NUREG/CR-5815  
BNL-NUREG-52311

# Evaluations of 1990 PRISM Design Revisions

Prepared by  
G. J. Van Tuyle, G. C. Slovik, B. C. Chan,  
A. L. Aronson, R. J. Kennett

Brookhaven National Laboratory

Figure 81. Peak Fuel, Clad, and Sodium Temperatures for Various Unscrammed Loss of Flow and/or Loss of Heat Sink Events.

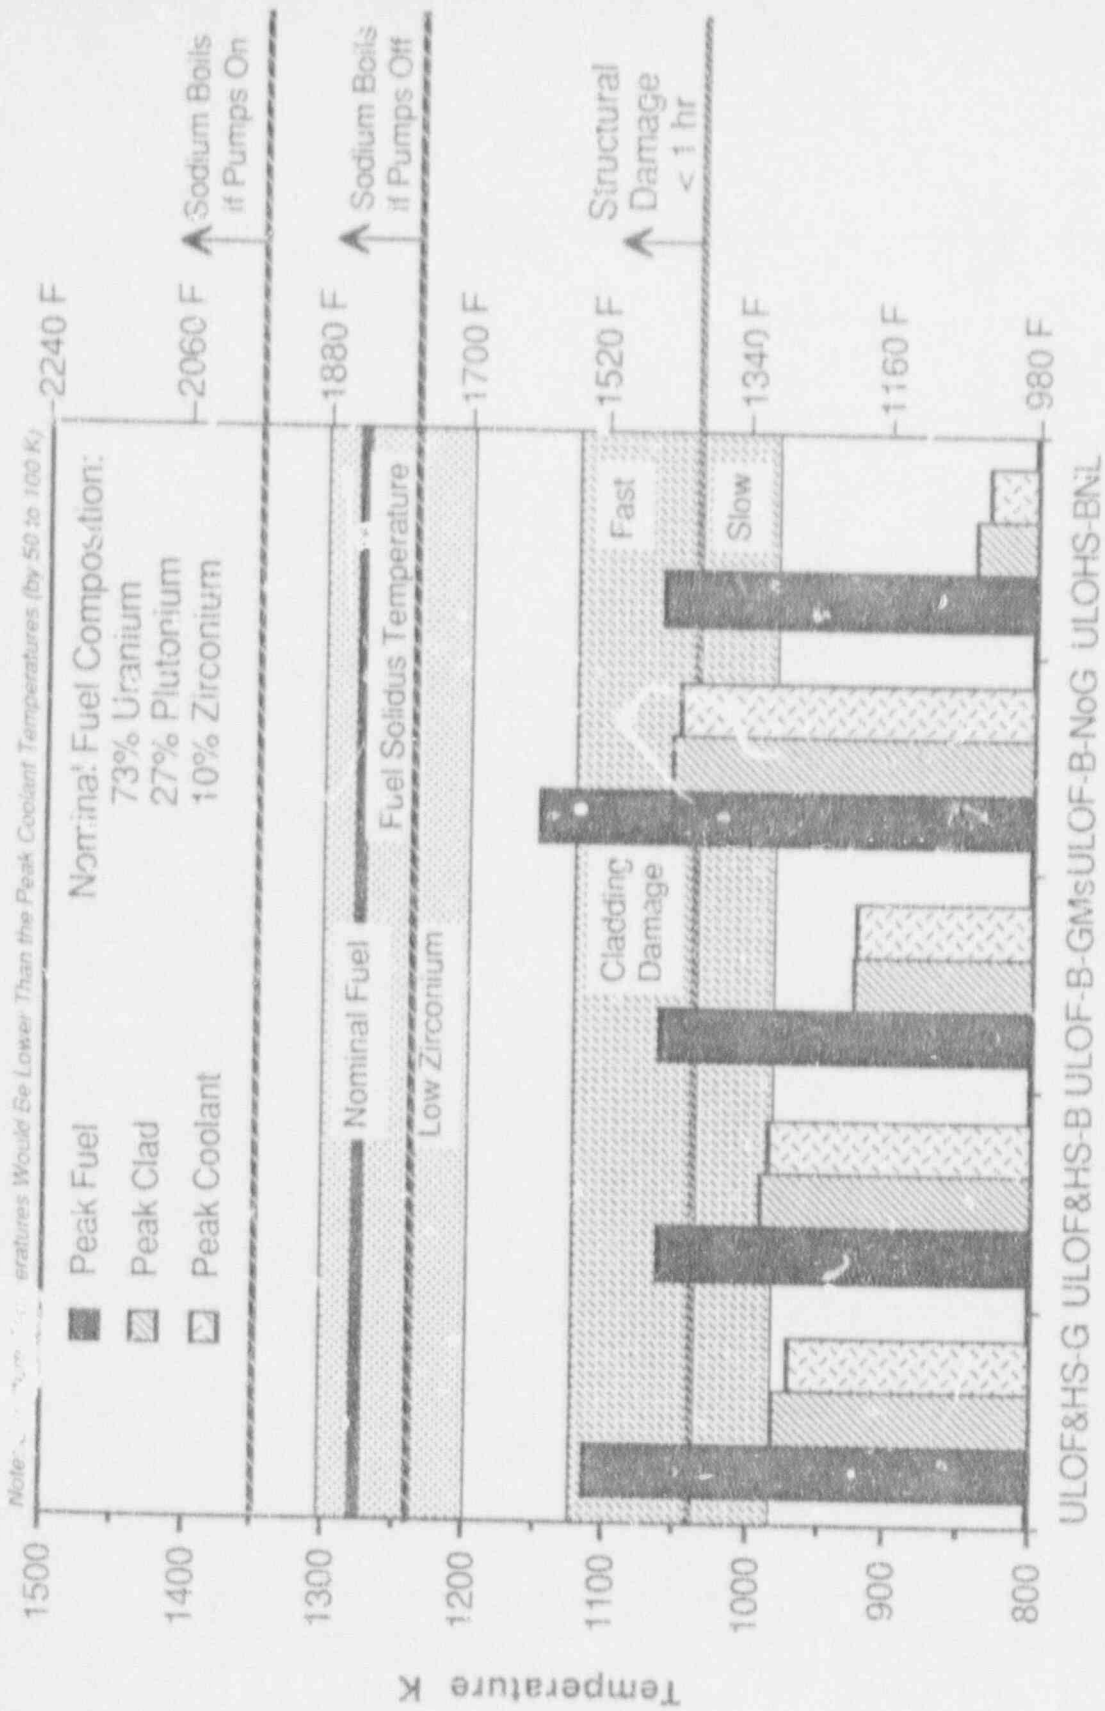
The peak fuel, clad, and sodium temperatures for the various unscrammed loss of flow and/or heat sink, along with key temperature limits are shown in Figure 81. GE's results for Event 2' are represented in the first set of bars, which directly correspond to those included in Figure 16. Peak temperatures from the equivalent BNL calculations are shown in the second set of bars. The difference in peak fuel temperatures remains unresolved. The peak fuel temperatures in the BNL calculation occur at the beginning of the transient, because tripping of the pumps triggers a quick response from the GEMs, which brings the power down before the system can begin to heat up. It is unclear to us why the fuel temperatures increase in the applicant's analysis. With respect to the peak clad and coolant temperatures, both analyses indicate similar temperature increases, which could lead to some cladding damage, depending on how the sparse data available is interpreted (see Section 4.16.3.2).

The 5th case, the unscrammed loss of heat sink does not appear to be a significant safety concern, unless it continues indefinitely. Certainly, the peak temperatures are very modest over the near term, as indicated in Figure 81.
